**RE: Clarification regarding Condition of Approval #8 of the Traffic Study and Addendum for  
The Two Fifty, SDR-62393 & DIR 63602, T64341**

The Transportation Engineering Division has reviewed and approved the traffic study and addendum for The Two Fifty, to be located on the southwest corner of Alta Drive and Rampart Boulevard. Per this study, the project is proposed to consist of 60 single-family detached dwelling units (SFDUs) and 3,020 multi-family dwelling units (MFDUs). Condition #8 states:

**RE: Traffic Study and Addendum for The Two Fifty, SDR-62393 & DIR 63602, T64341**

**THE TWO FIFTY**

Figure 10. Additional Background Traffic Estimates (Scenario 1)

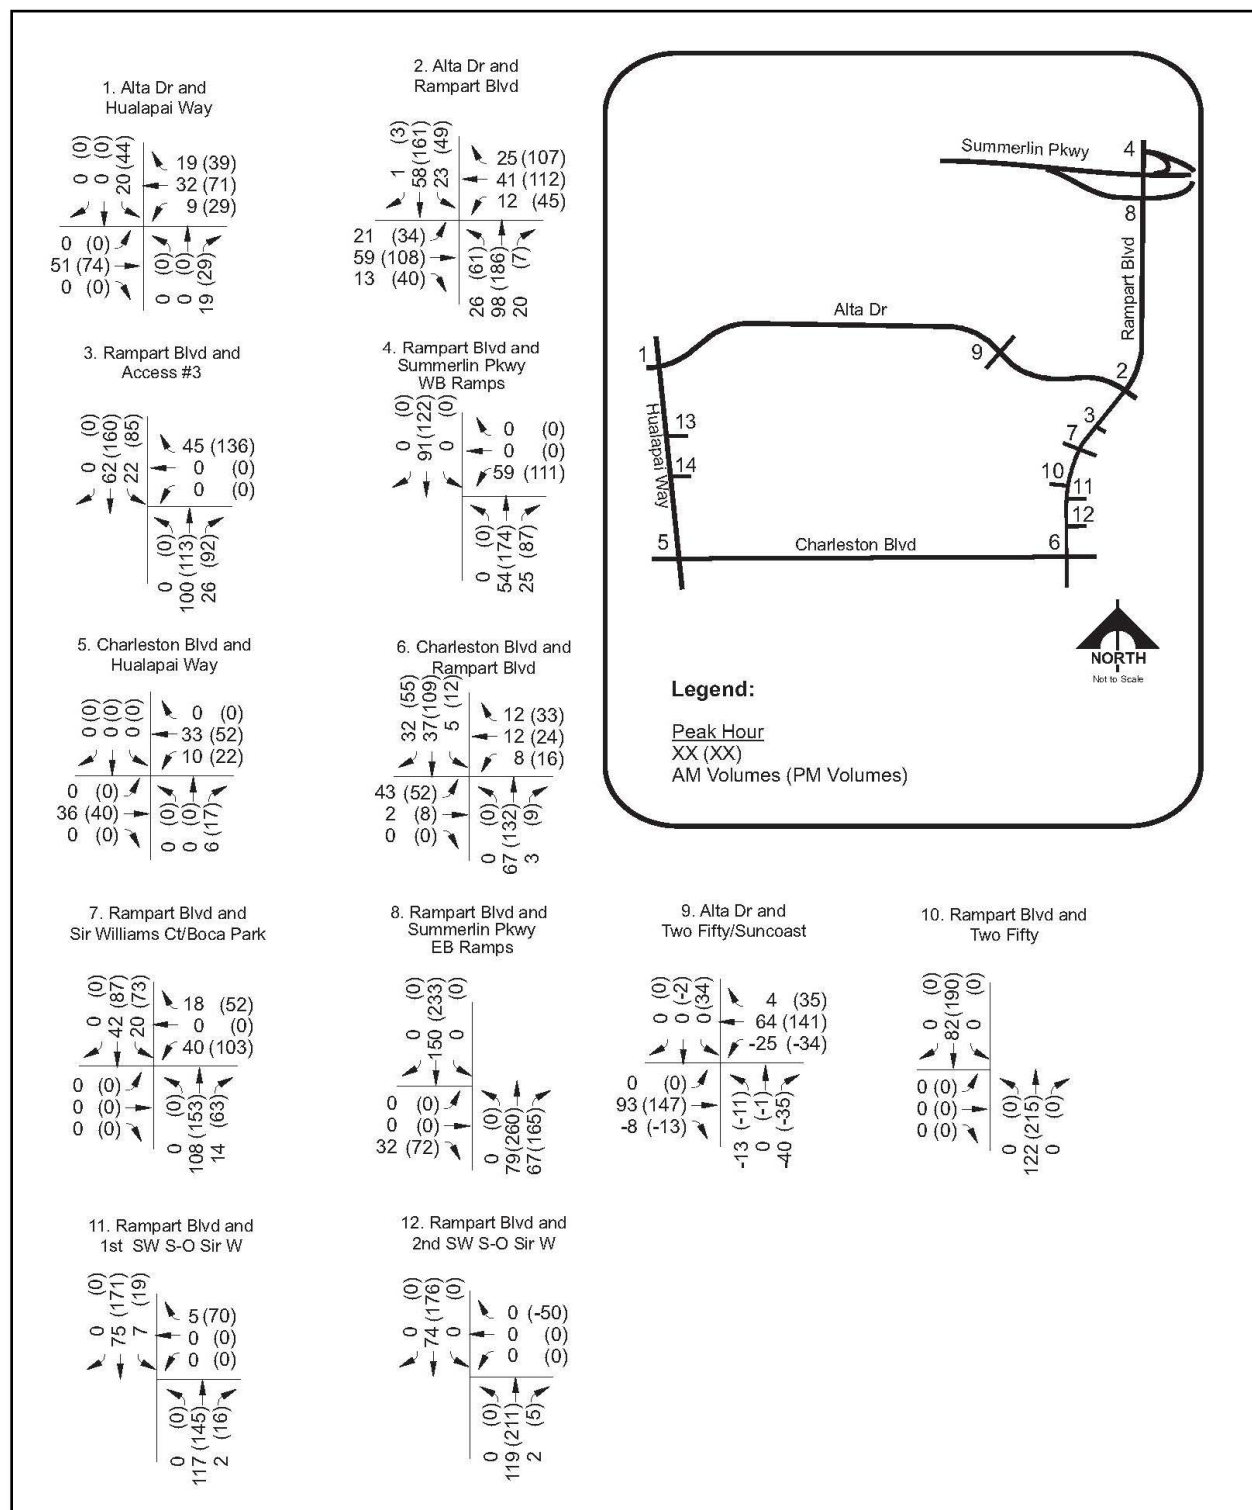
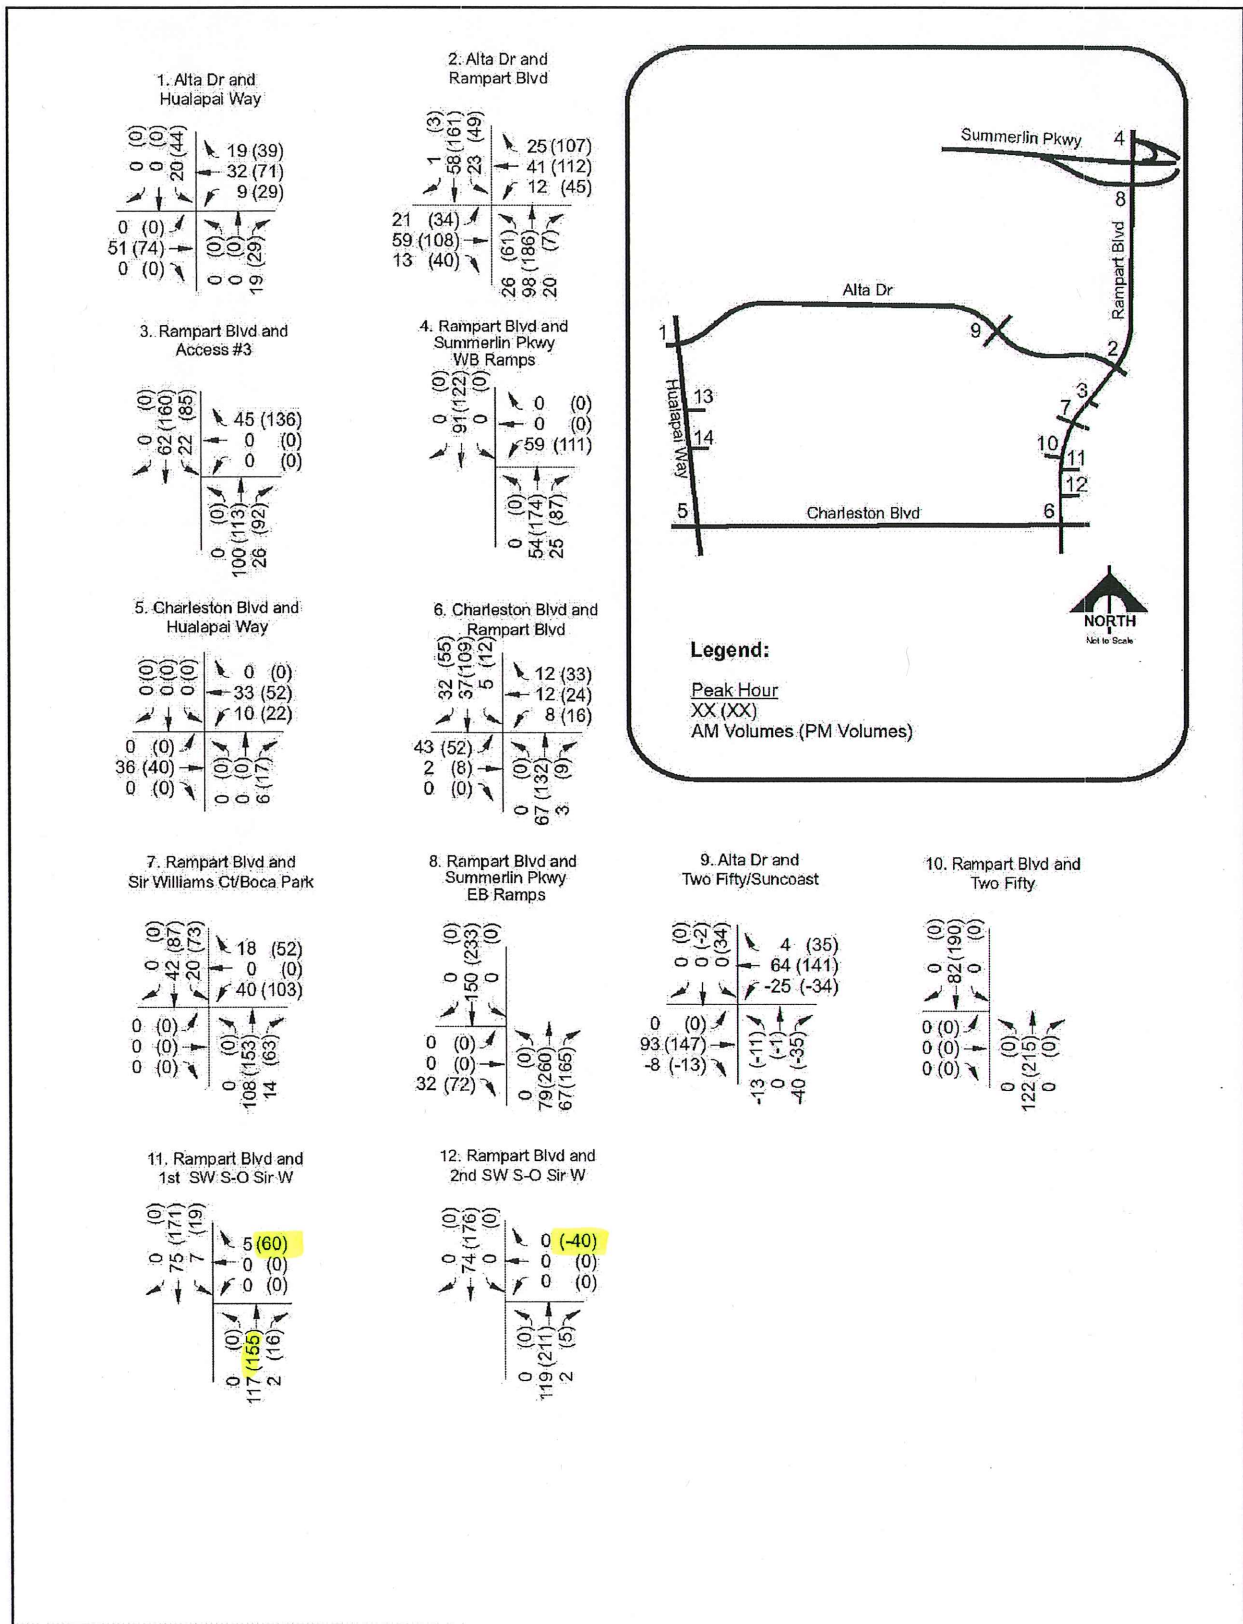
**Comment:** "2. On Figure 18, Background-Plus-Project PM peak Scenario 1, the following volumes appear to be in error:

**Response:** Please find corrected Figures 10, 11 and 13 for background traffic attached. The change in left-turn and U-turn access was assumed to have a minor impact on the distribution of background right-turn demands. The corrected volumes added to Figure 16 trip assignments yields the Figure 18 volumes.
